# SR 92 REALIGNMENT AND WIDENING

## Value Engineering Study Report

Preliminary Design Stage

May 2008

Alternate No. BRC-3  
sheet 3/5

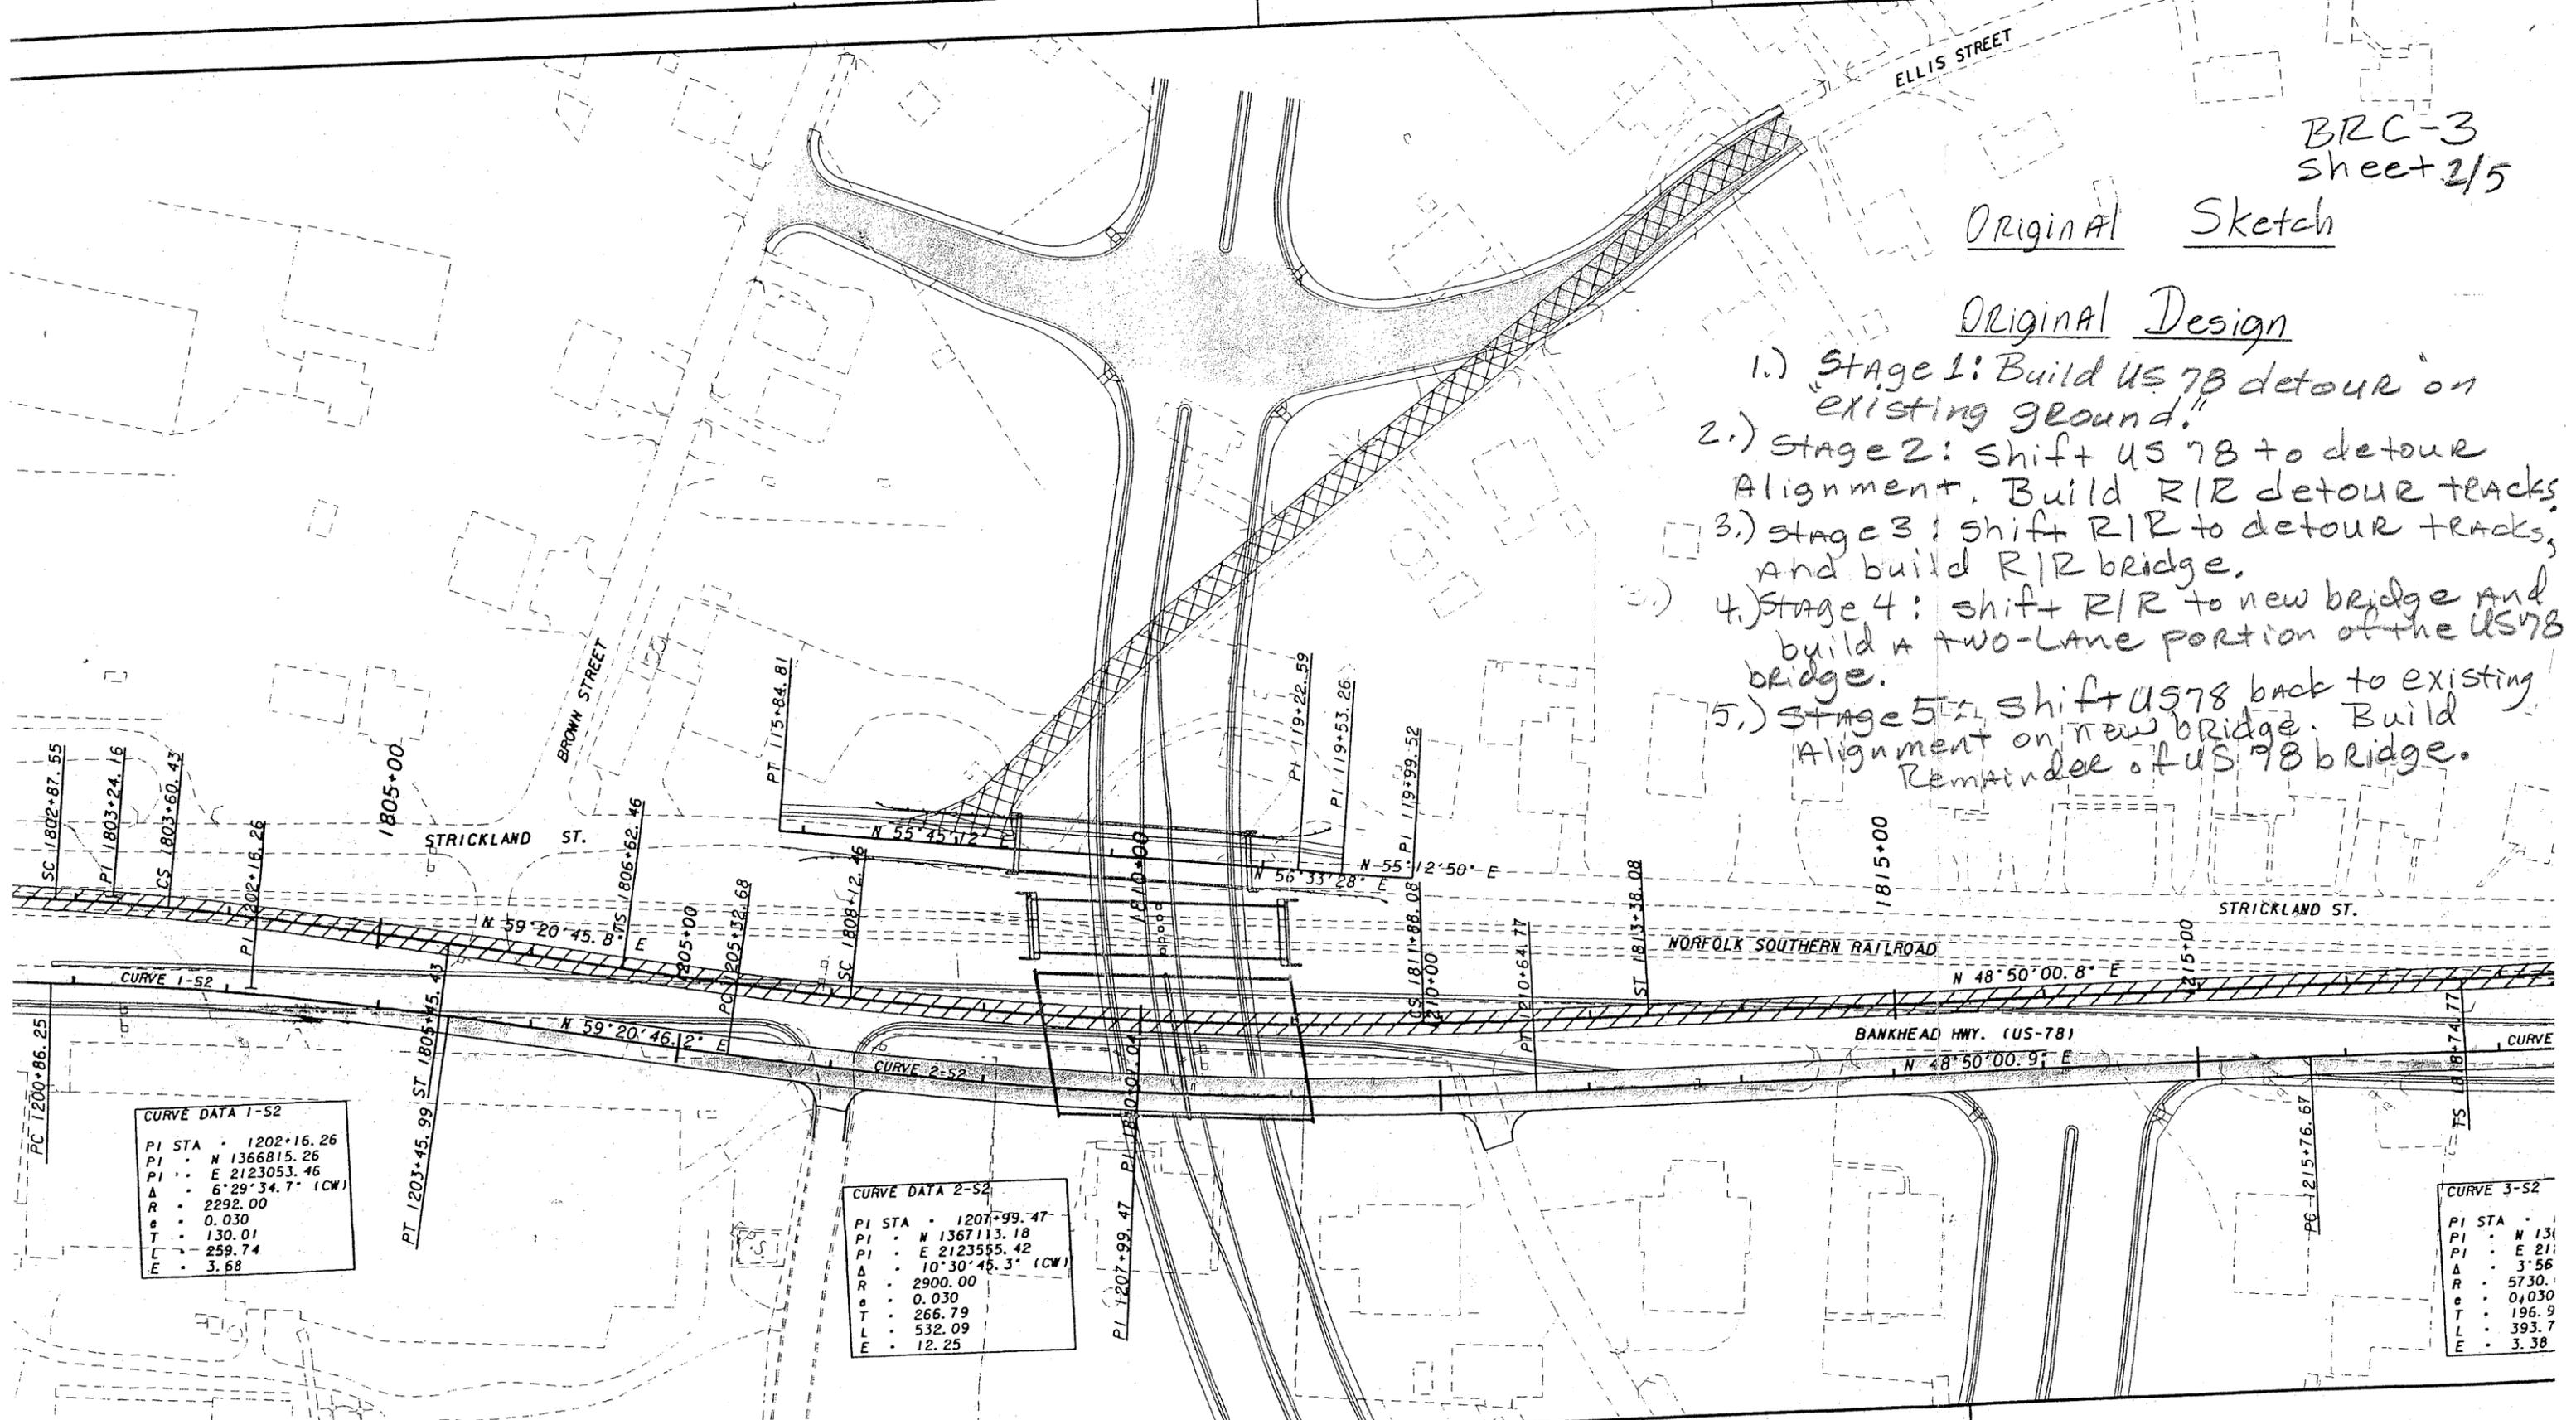
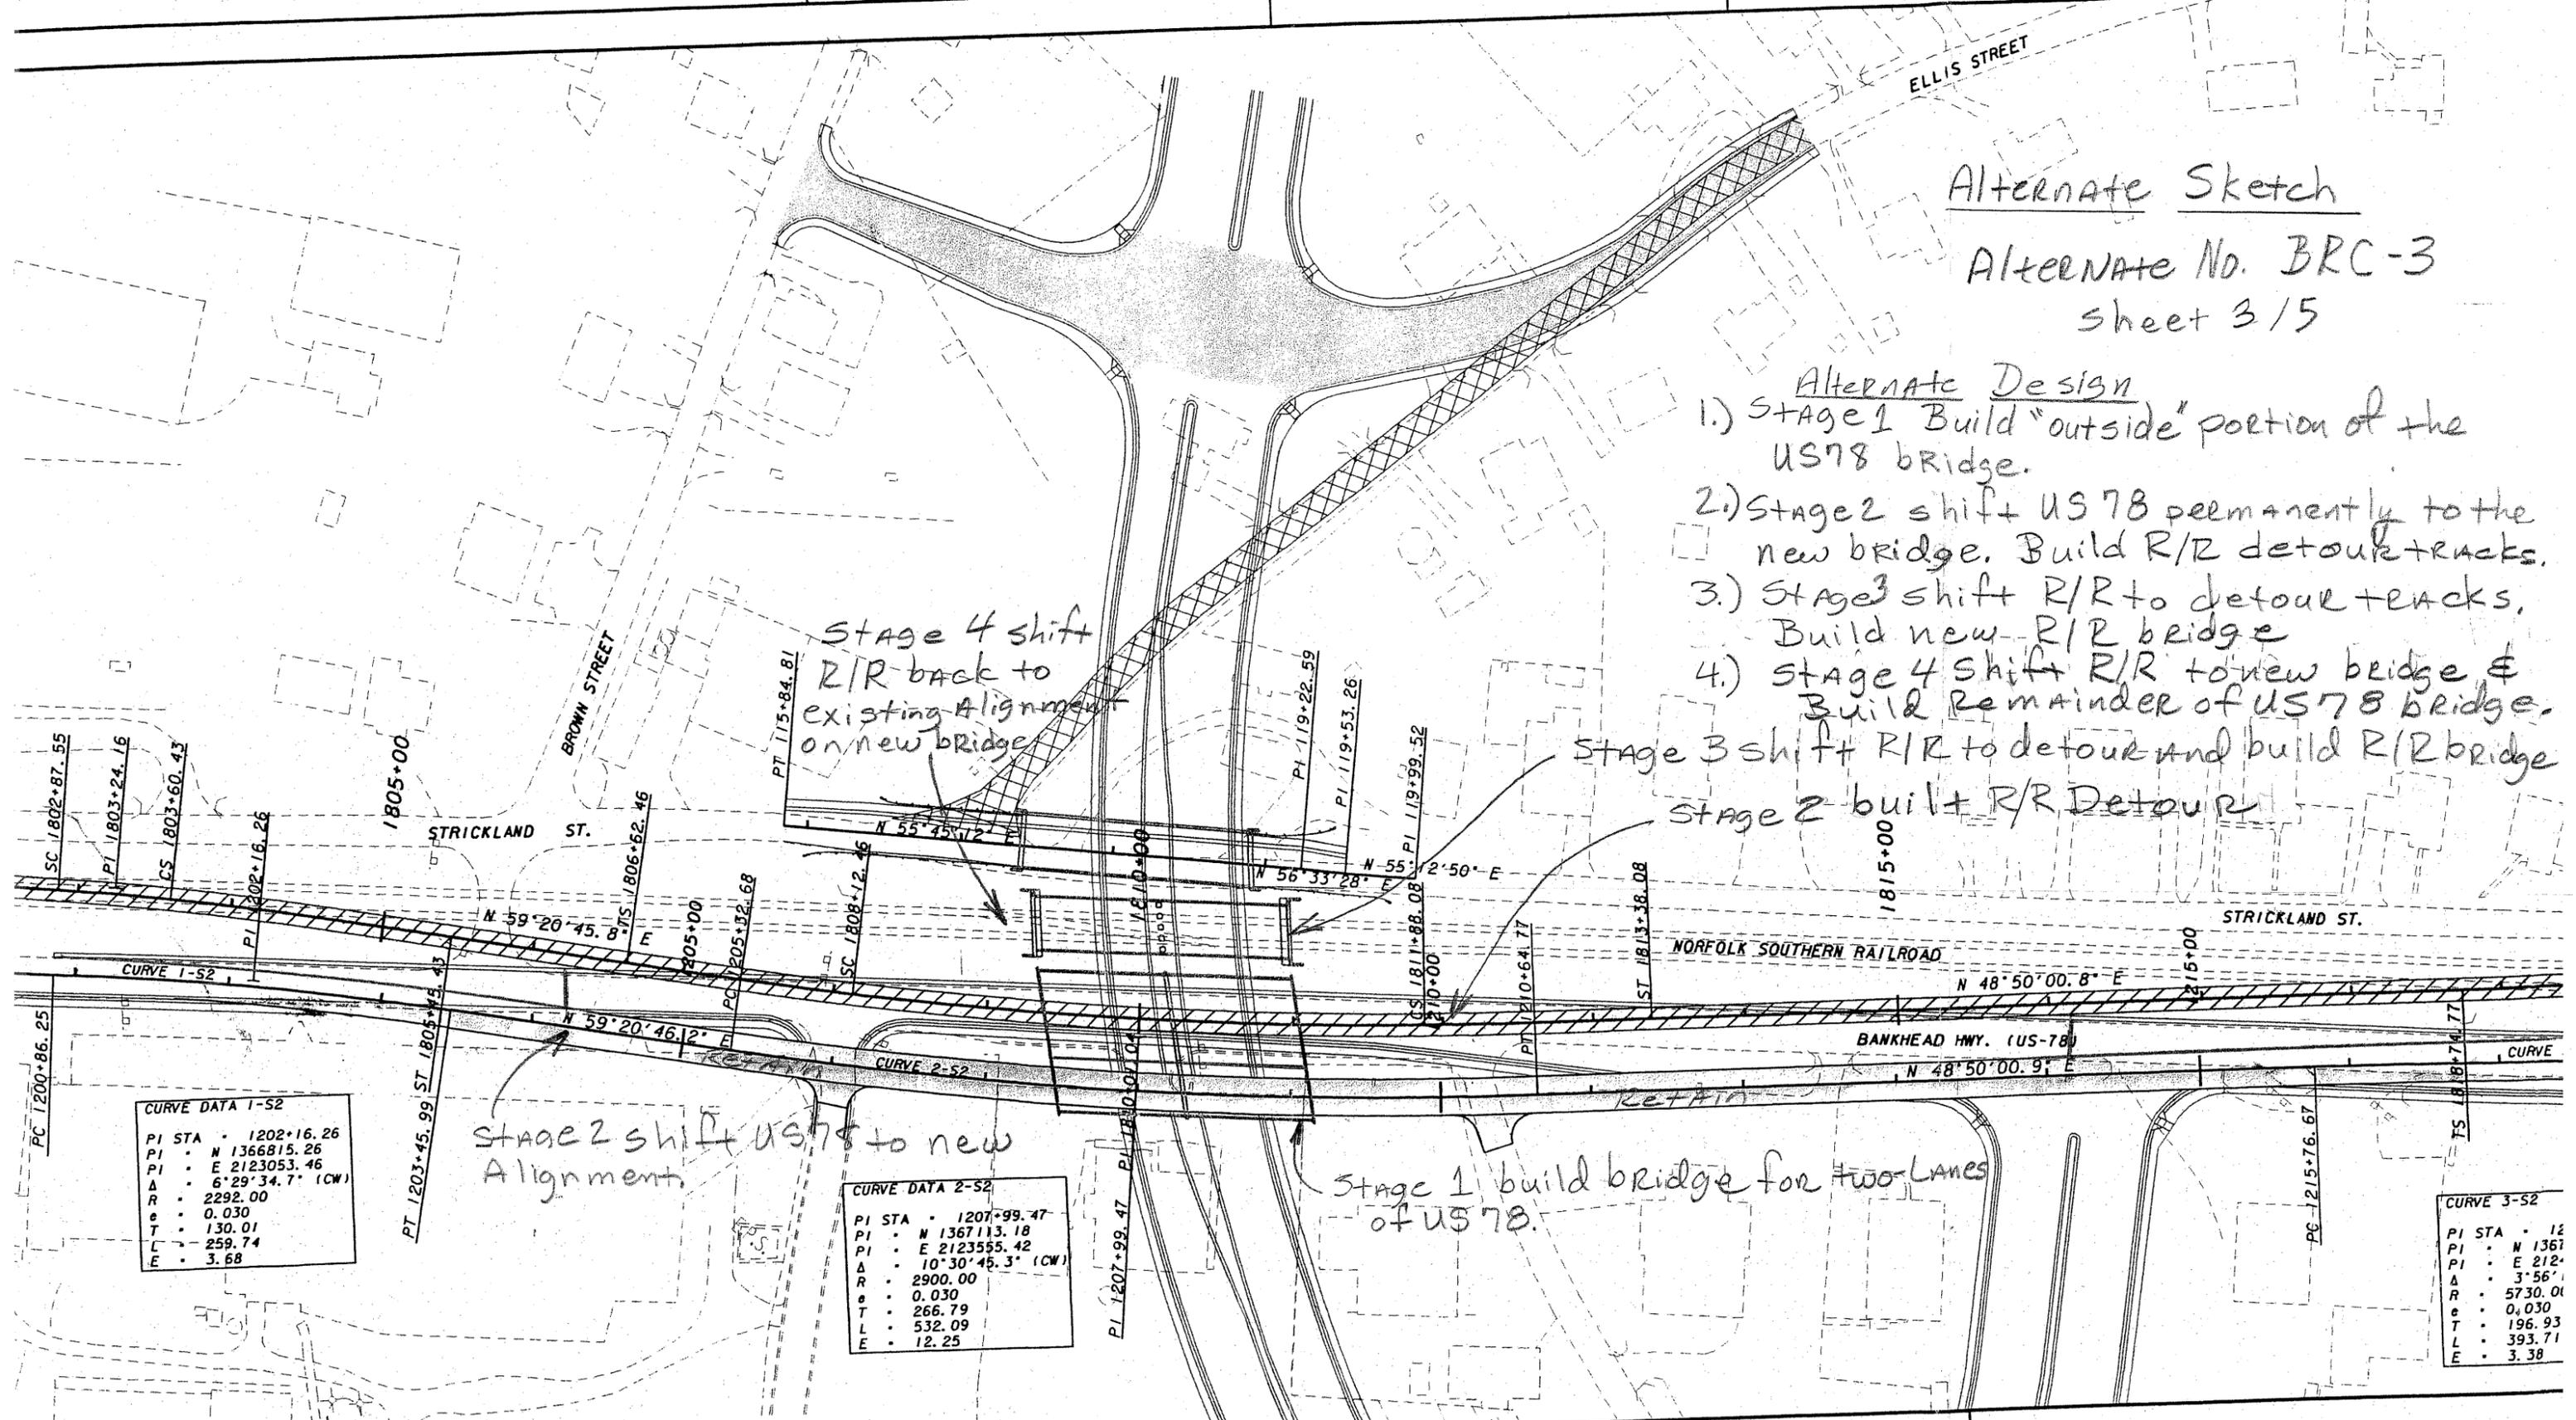
This alternative proposes to shift US 78 once to its permanent location. Stage 1 originally involves building the outside portion of the US 78 bridge, while US 78 would remain on the existing alignment. Stage 2 would involve shifting US 78 permanently to the portion of US 78 bridge built in Stage 1.

The shifted US 78 under this proposed design may require higher design standards than are proposed under the current design since the current detour is designed for temporary standards. This would require any future widening of US 78 to be to the north and away from the developed property.

Existing US 78 pavement will have to be rebuilt in the area of the railroad detour tracks under the current design. Since under the proposed design the US 78 roadway would remain on the shifted detour alignment, the existing US 78 pavement removed for the railroad detour would not have to be rebuilt.

- 1.) Stage 1 Build "outside" portion of the US78 bridge.
- 2.) Stage 2 shift US 78 permanently to the new bridge. Build R/R detour tracks.
- 3.) Stage 3 shift R/R to detour tracks. Build new R/R bridge
- 4.) Stage 4 shift R/R to new bridge & Build Remainder of US78 bridge.

Stage 3 shift R/R to detour and build R/R bridge  
Stage 2 built R/R Detour

# ALTERNATIVE RAMP PROFILE

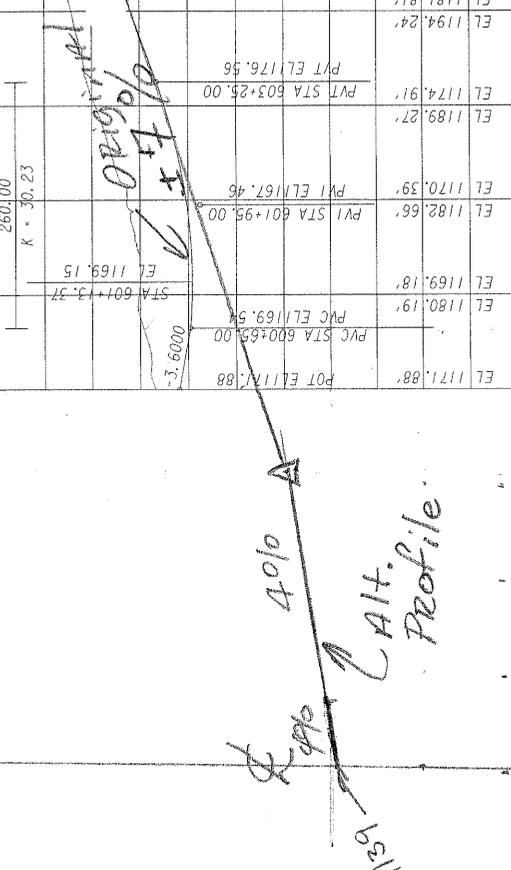
Move the SR 92/US 78 ramp south to Cooper Street and provide access to the portion of Dorsett Street north of Cooper Street via a short connecting road that would operate with right-in right-out access from SR 92. Connect Dorsett Street to the portion of Cooper Street east of Dorsett Street. Cul-de-sac Dorsett Street just north where the alternative ramp crosses it.

Handwritten notes in a cloud shape: "Add High-Density Residential" and "Remove existing parking" with arrows pointing to specific areas on the map.

Handwritten notes: "The exit will be at Connally Drive of US-78 and Durbin at SR 92" and "Alternative Design" with arrows pointing to the proposed barrier area.

PROJECT **SR 92 Realignment & Widening (Douglas & Paulding Counties)** ALTERNATIVE NO *TS-W-5*  
*Georgia Department of Transportation*

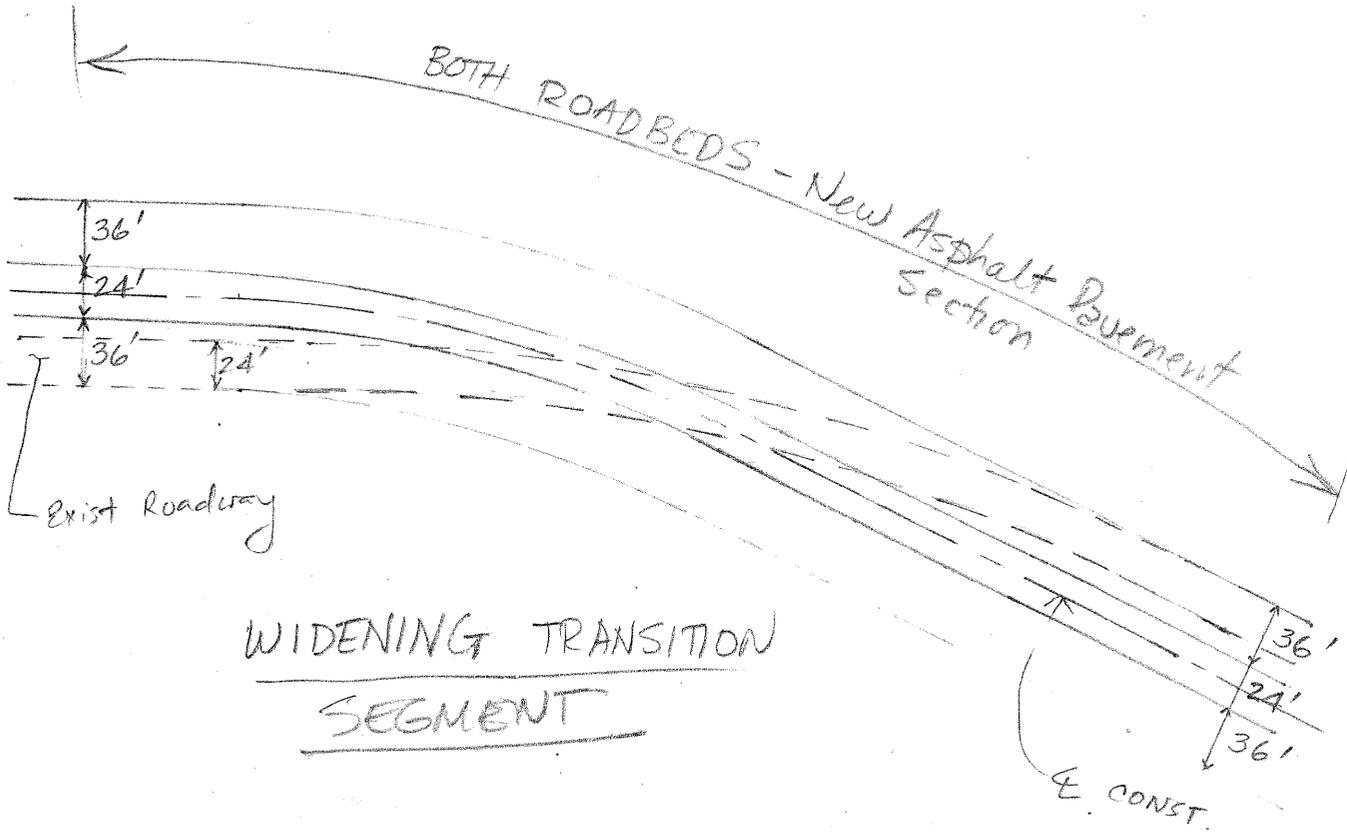
Retain the existing asphalt pavement and overlay the existing roadbed. Widen the two-lane roadbed to a three-lane section by adding a 12-ft.-wide full asphalt concrete pavement section to the inside. Construct the opposite roadbed with a full depth asphalt concrete pavement section. Add 6.5-ft.-wide asphalt concrete shoulders to the outside of both roadbeds.

This alternative trades service life for cost savings.

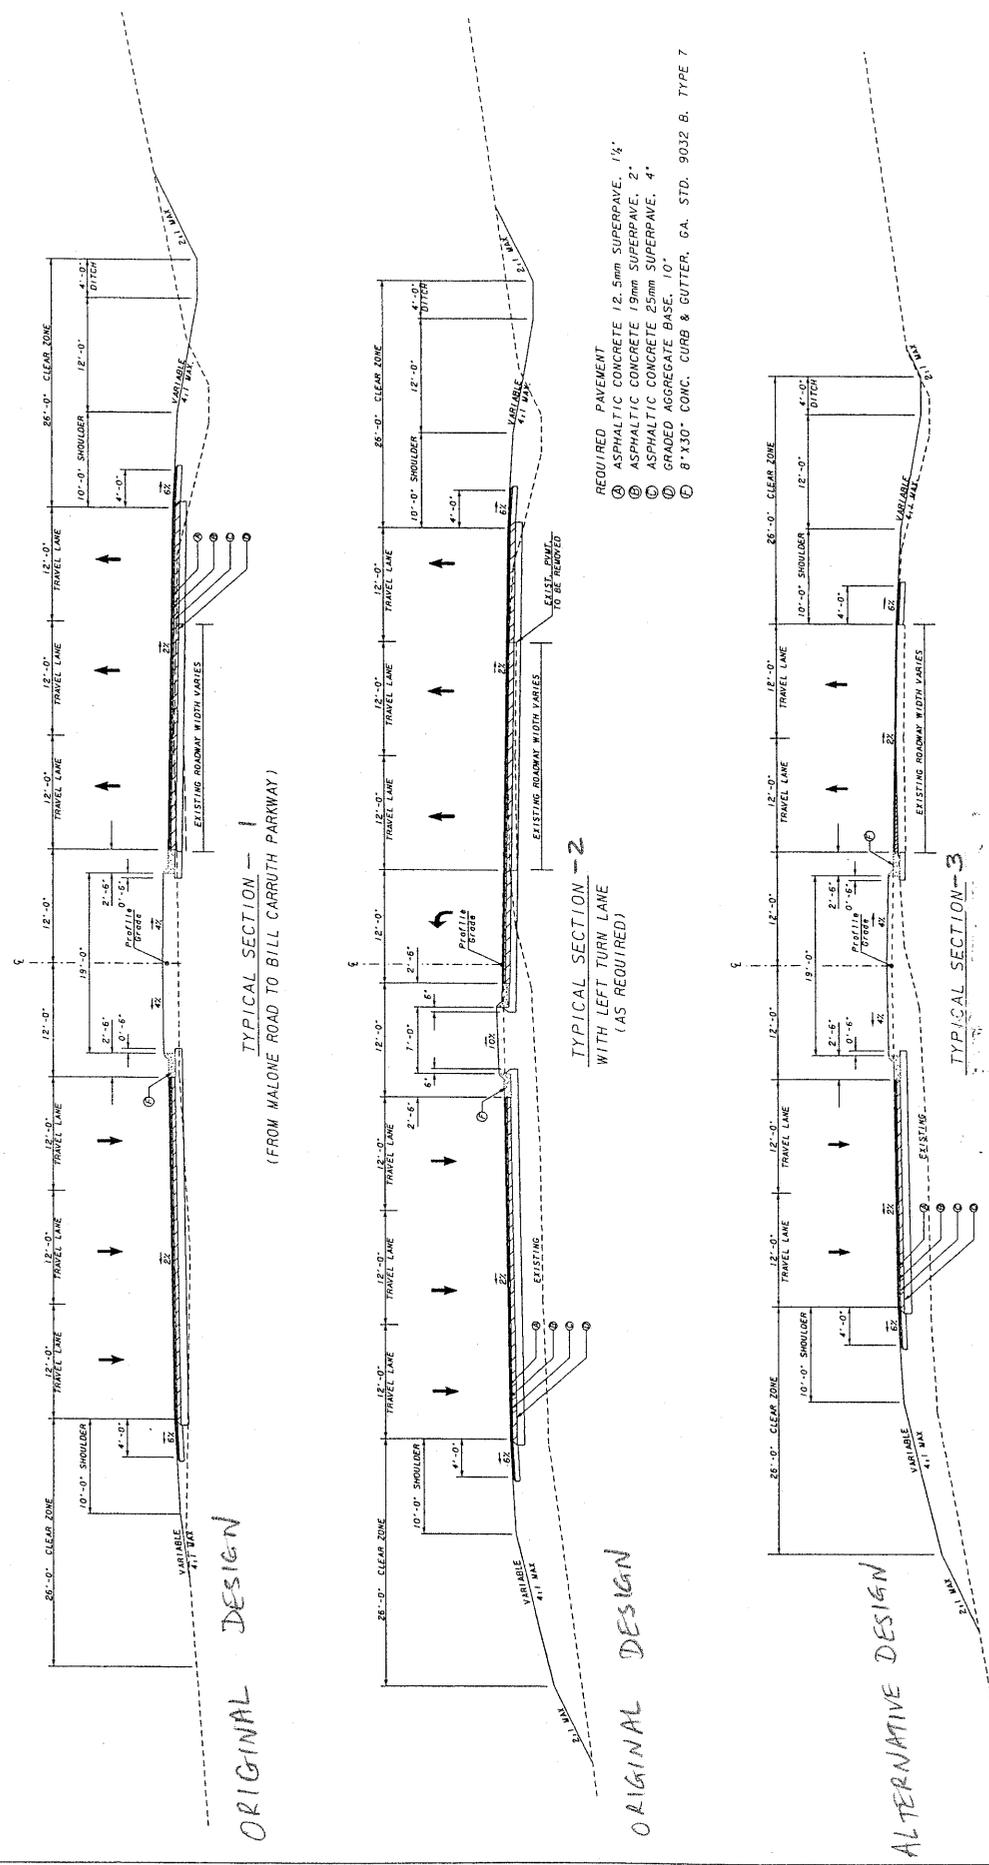
The current SR 92 widening project calls for completely new PCC concrete lanes and RCC outside shoulders from Malone Road to the Bill Carruth Parkway for a total of 6.5 miles. The proposed highway will provide six 12-ft.-wide lanes and 6'-6" outside shoulders. According to the traffic analysis, the need for six lanes from Malone Road to the Bill Carruth Parkway is to accommodate design year 2035. From Bill Carruth Parkway to Nebo Road lanes are specified for design year 2035.

Provide a four-lane roadway for the opening year 2015 from Malone Road to the Bill Carruth Parkway. Build the additional two outside lanes within this section at a later date as dictated by traffic needs. Purchase the right-of-way for the full six-lane facility.
